Supplementary Papers for Planning Committee

PLANNING COMMITTEE – 14 MARCH 2024

ADDENDUM SHEET

Land at 40 Dorset Lake Avenue, Poole

SITE, BLOCK & LOCATION PLANS

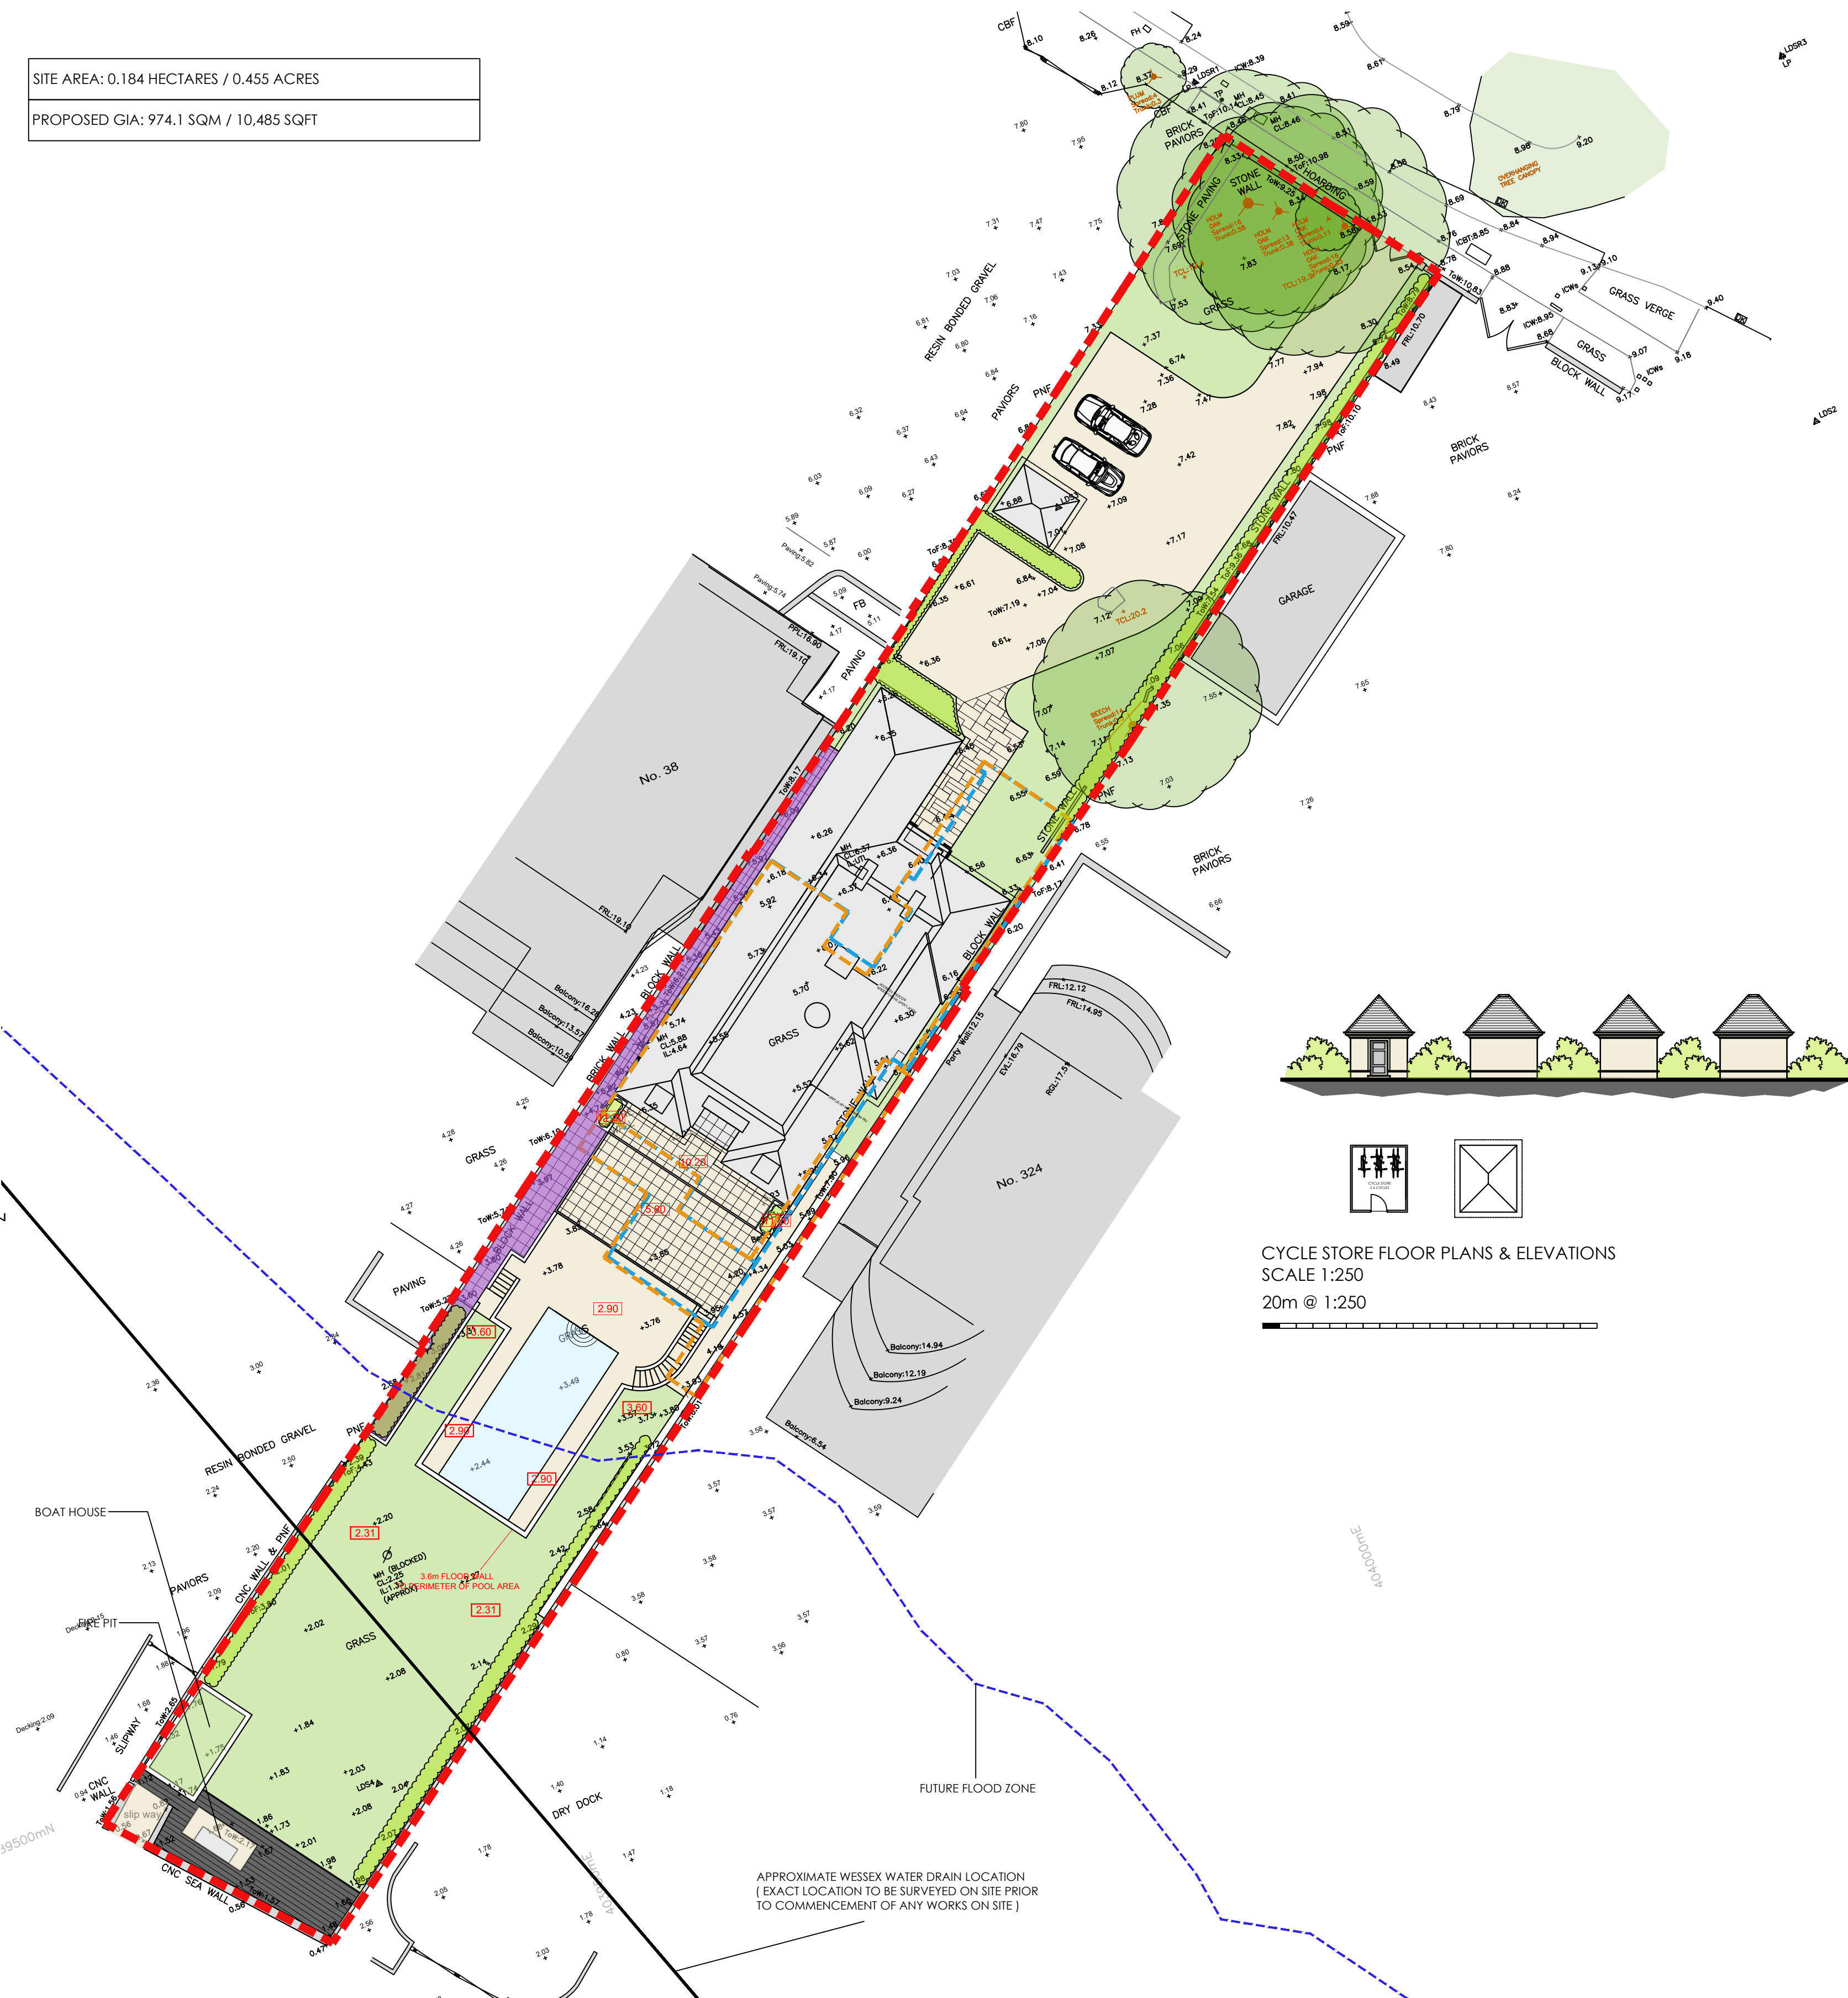
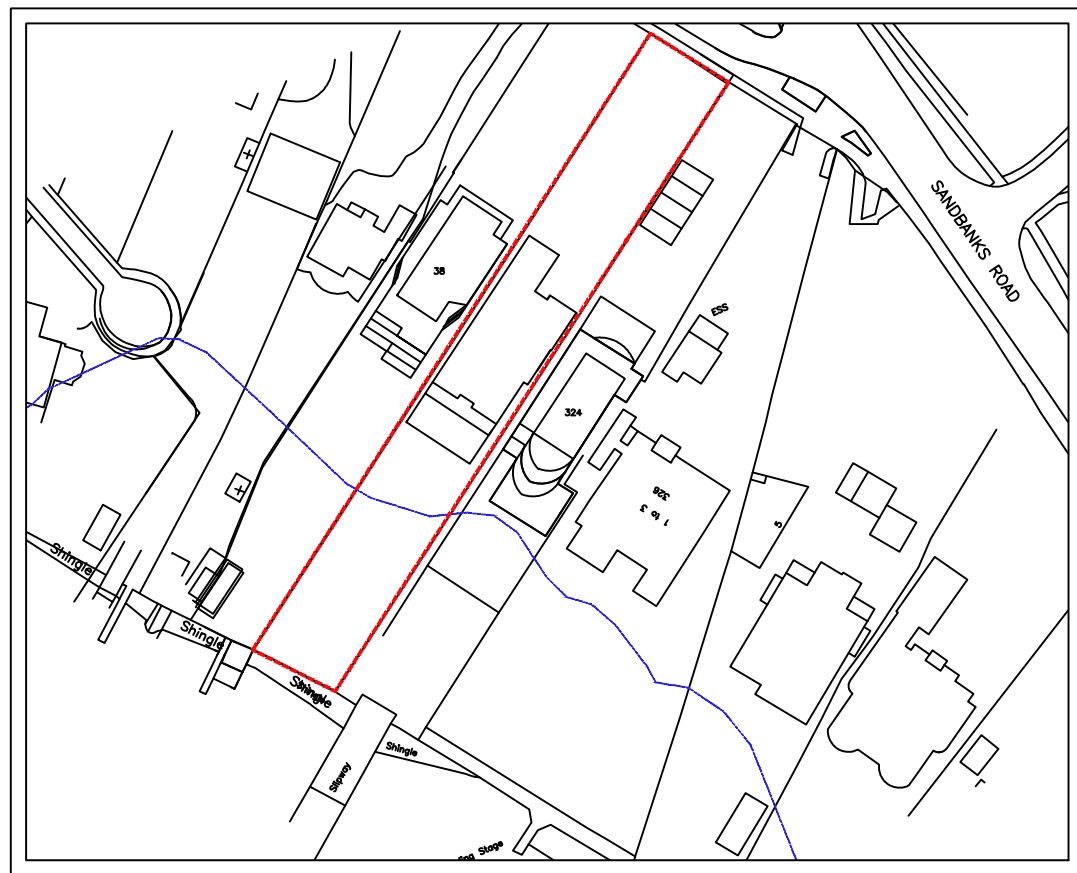
Amended plans received to show design and location of cycle store and height of boundary walls following further survey information (attached).

Q	• Amendments following updated topographical survey information, • Cycle store added	26.02.24	WD
P	Scale bars added	15.12.23	WD
O	Outline of planning approvals removed & rear terrace reduced to be 0.9m further away from north west boundary	11.12.23	WD
N	Outline of planning approval added	15.11.23	WD
M	Landscape amended following tree consultant comments	17.11.22	WD
L	planners comments	08.11.22	BC
K	various outlines removed	29.04.22	BC
J	amendments to CLEUD approval	24.05.22	BC
I	rear stairs moved	11.05.22	BC
H	clients comments	31.03.22	BC
G	Planners comments	16.03.22	WD
F	• Ground floor & first floor balcony @ the rear pulled North East 750mm. • Proposed level added to first floor balcony. • North west elevation, outline of approved amended. • 324 Sandbanks Road patio area level amended. • Outline of proposed flats currently under construction @ 38 Dorset Lake Avenue added to rear elevation • Outline of proposed flats currently under construction @ 38 Dorset Lake Avenue added to street scene	05.05.21	WD

9101/200-Q – Site, Block and Location plans, received 27 February 2024
9101/201-N – Floor Plans, received 15 December 2023
9101/202-P – Elevations 1, received 27 February 2024
9101/203-P – Elevations 2, received 27 February 2024
9101/204-J – Street scene and boathouse, received 27 February 2024
9101/205-O – Drainage, 27 February 2024

INDICATIVE DRAINAGE PLAN

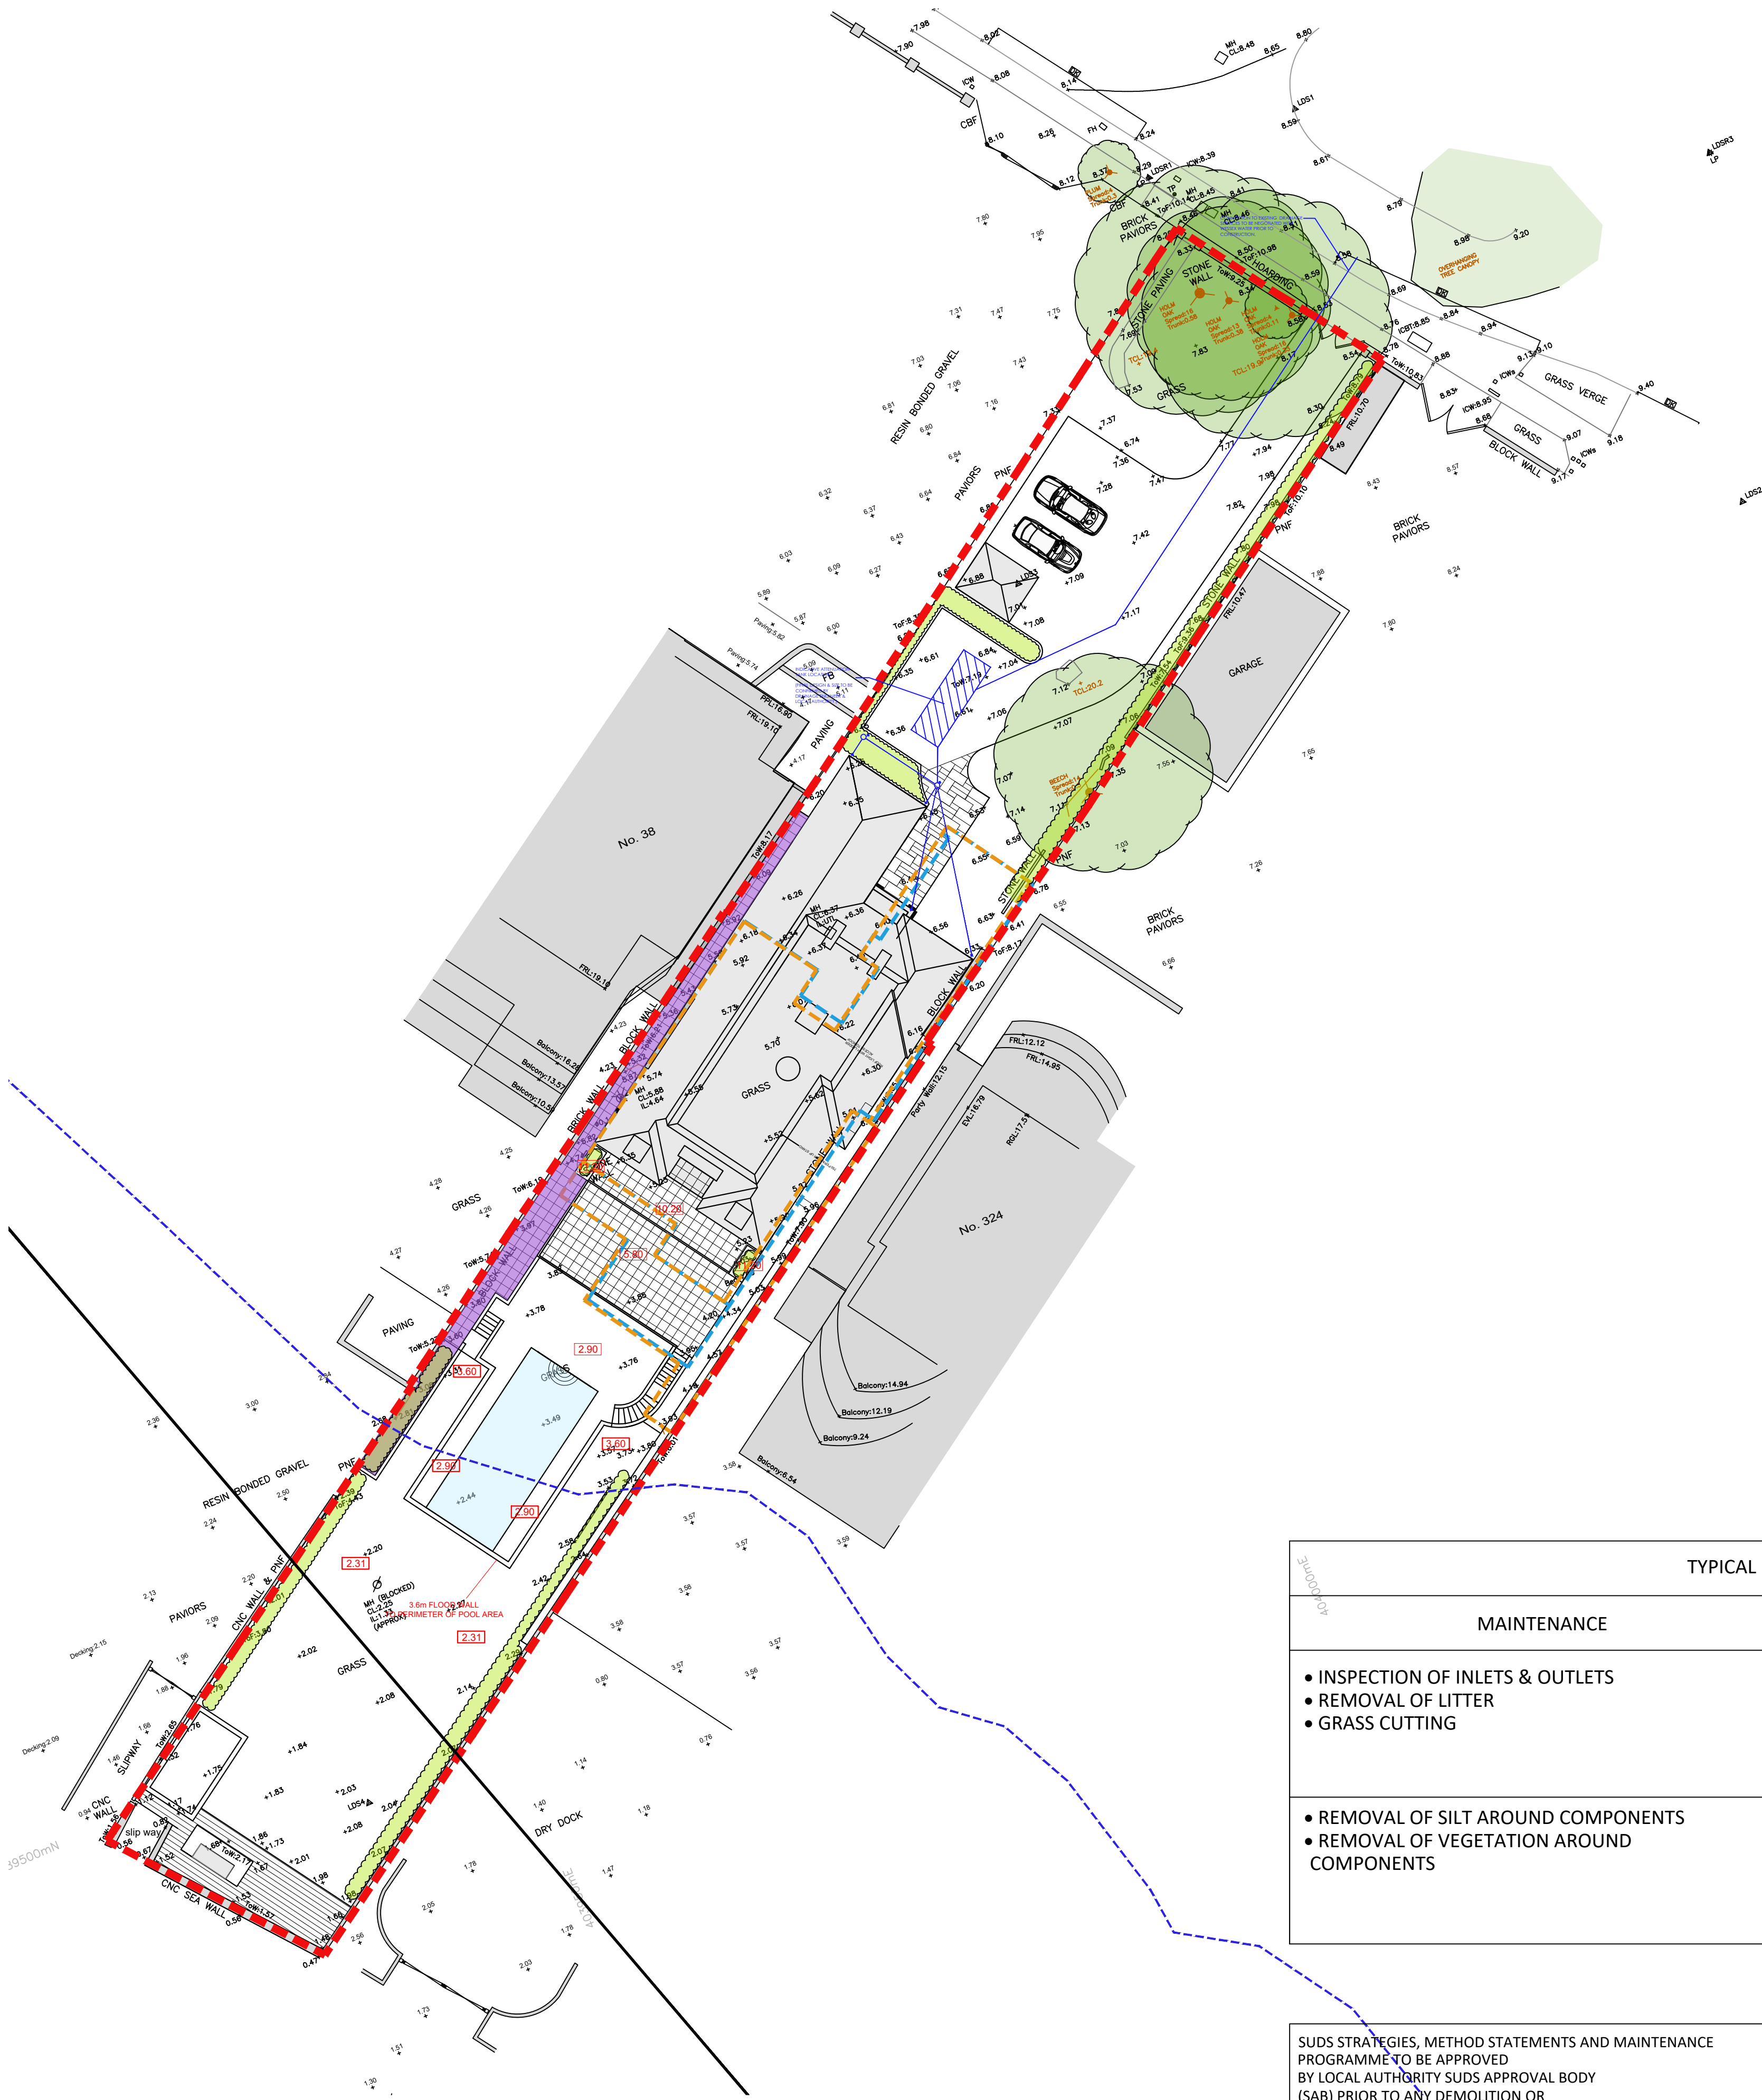
O	- Amendments following updated topographical survey information. - Cycle store added	26.02.24	WD
N	Scale bars added	15.12.23	WD
M	Outline of planning approvals removed & rear terrace reduced to be 0.9m further away from north west boundary	11.12.23	WD
L	Attenuation tank relocated following comments.	22.09.23	WD
K	Landscaping amended following tree consultant comments	17.11.22	WD
J	REAR STAR LOCATION MOVED	08.11.22	WD
I	REAR STAR LOCATION MOVED	11.05.22	WD
H	PLANNERS COMMENTS	31.03.22	WD
G	PLANNERS COMMENTS	24.03.22	WD
F	- Ground floor & first floor balcony @ the rear pulled North East 750mm. - Proposed level added to first floor balcony. - North west elevation, outline of approved amended. 324 Sandbanks Road patio area level amended. - Outline of proposed flats currently under construction @ 38 Dorset Lake Avenue added to rear elevation - Outline of proposed flats currently under construction @ 38 Dorset Lake Avenue added to street scene	05.05.21	WD

STREET SCENE & BOAT HOUSE

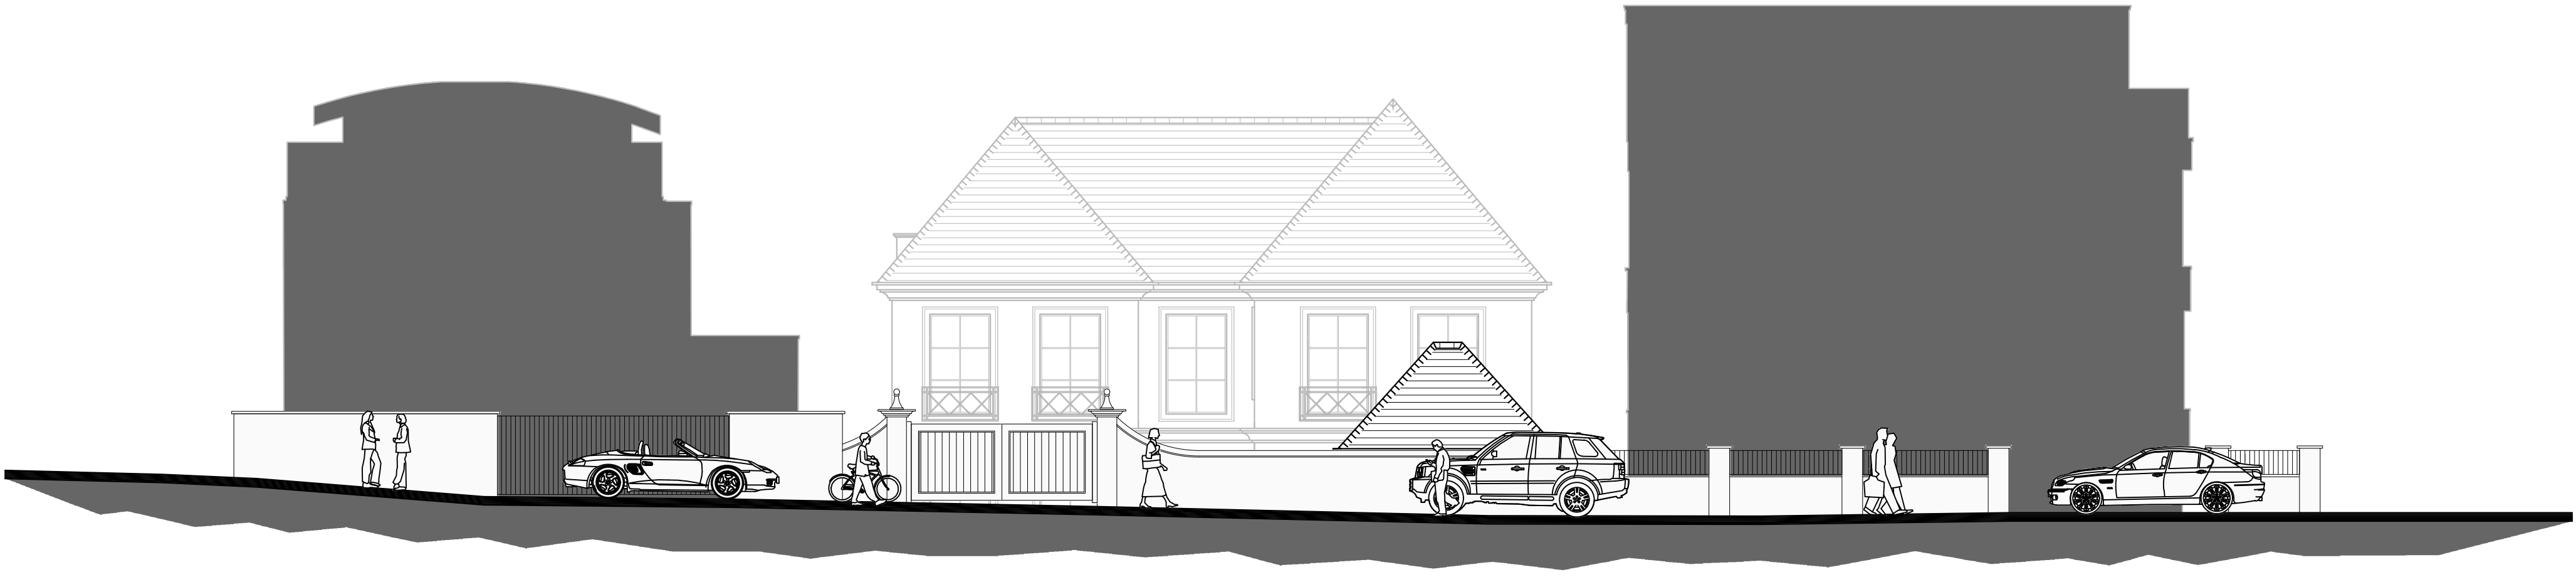
J	- Amendments following updated topographical survey information. - Cycle store added	26.02.24	WD
I	planners comments	8.11.22	BC
H	various outlines removed	29.06.22	BC
